## Exhibit B

#### Technical Specification Pages Marked Up With Proposed Changes

### Monticello Nuclear Generating Plant Supplement 1 to License Amendment Request Dated July 5, 1995

#### Table 3.2.1 - Continued

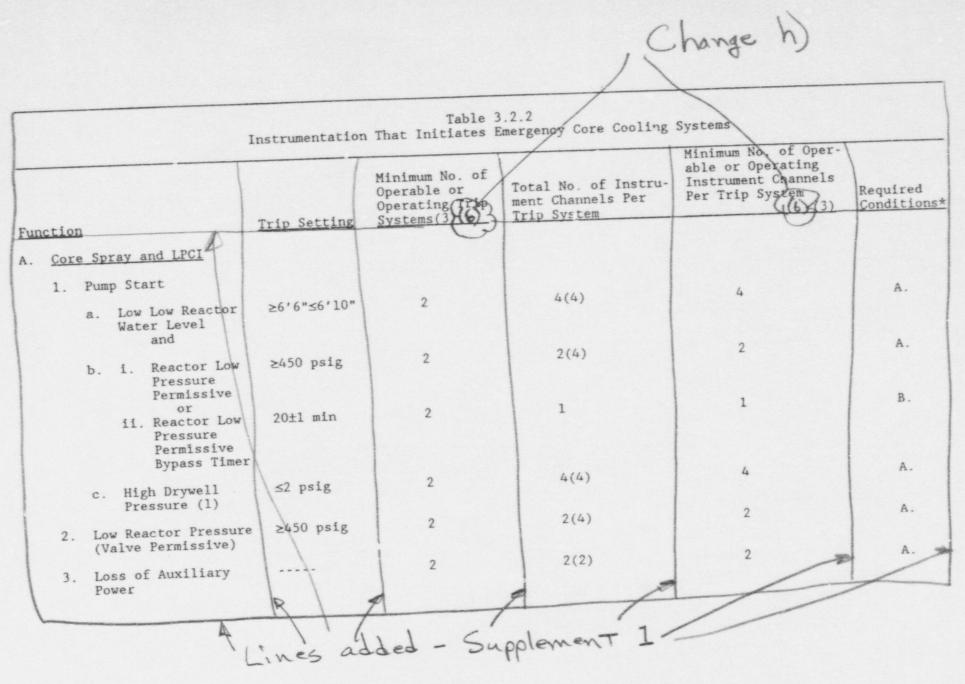
Change 8'

For Groups 4, 5 and Roadtor Pressure Interlocks there shall be two operable or tripped trip systems for each function.

For Groups 4, 5 and Reactor Pressure Interlocks upon discovery that miximum requirements for the number of operable or operating trip systems or instrument channels are not satisfied action shall be initiated to: Satysfy the requirements by placing appropriate chaphels or systems in the tripped condition/ (a) place the plant under the specified required conditions using normal operating procedures,

- (1) There shall be two operable or tripped trip systems for each function. A channel (a shared channel is considered one channel) may be placed in an inoperable status for up to 6 hours for required surveillance without placing the trip system in the tripped condition provided that at least one other operable channel in the same trip system is monitoring that parameter.

- (2) Upon discovery that minimum requirements for the number of operable or operating trip systems or instrument channels are not satisfied action shall be initiated as follows:

- (a) With one required instrument channel inoperable in one or more trip functions, place the inoperable channel(s) or trip system in the tripped condition within 12 hours, or

- (b) With more than one instrument channel inoperable for one or more trip functions, immediately satisfy the requirements by placing appropriate channels or systems in the tripped condition, or

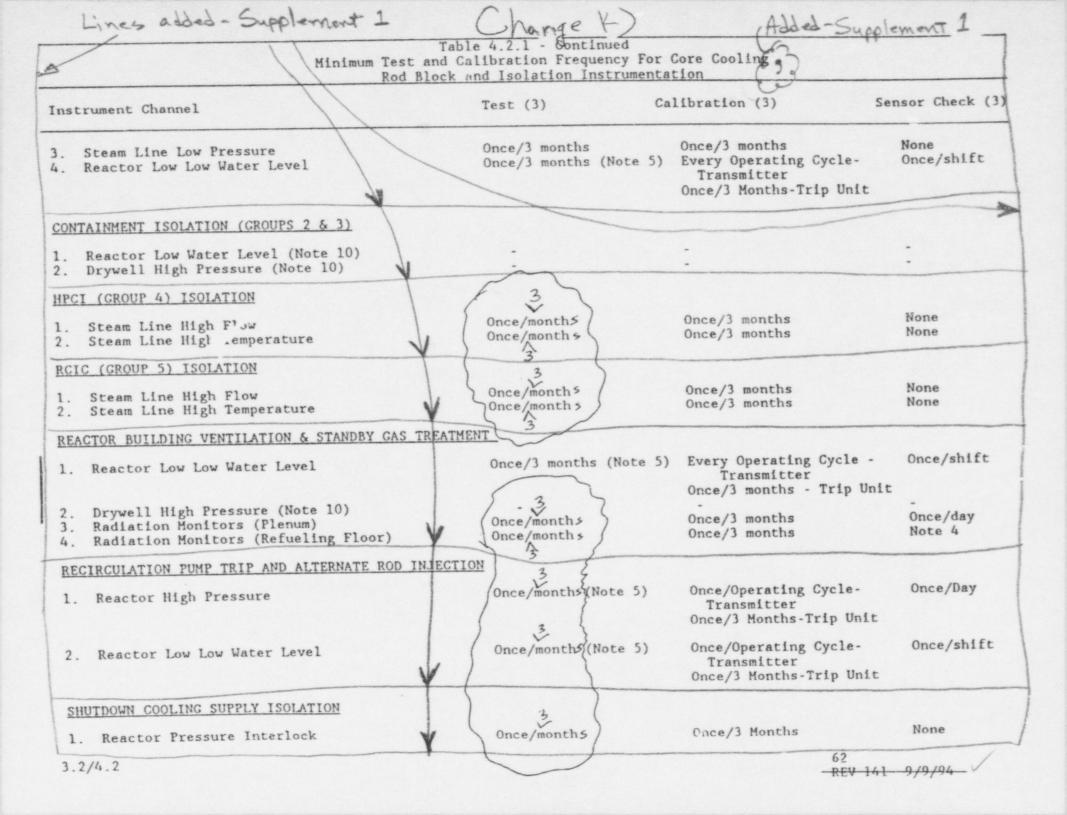
Lines added - Supplement I	Change	K) (Ad)	Led Supplement 2
Minimum Te R Instrument Channel	Table 4.2.1 est and Calibration Frequency od Block and Isolation Instru	For Com Carlo	
	Test (3)	Calibration (3)	Sensor Check (
<ol> <li>ECCS INSTRUMENTATION</li> <li>Reactor Low-Low Water Level</li> <li>Drywell High Pressure</li> <li>Reactor Low Pressure (Pump Start)</li> <li>Reactor Low Pressure (Valve Permissive)</li> <li>Undervoltage Emergency Bus</li> <li>Low Pressure Core Cooling Pumps Discharge Pressure Interlock</li> <li>Loss of Auxiliary Power</li> <li>Condensate Storage Tank Level</li> <li>Reactor High Water Level</li> </ol>	Once/months(Note 5) 3 Once/months Once/months Once/months Refueling Outage Conce/months Refueling Outage Refueling Outage Refueling Outage Once/months(Note 5) 3	Every Operating Cycle - Transmitter Once/3 months - Trip Unit Once/3 months Once/3 months Once/3 months Refueling Outage Noce/3 months Refueling Outage Refueling Outage Every Operating Cycle - Transmitter Every 3 months -	Once/Shift None None None None None None None

Table 4.2.1		
	Minimu	m Test and Calibration Freq		
		Rod Block and Isolation Ir		Sensor Check (3)
Inst	rument Channel	Test (3)	Calibration (3)	Sensor Check (3)
ECO	CS INSTRUMENTATION
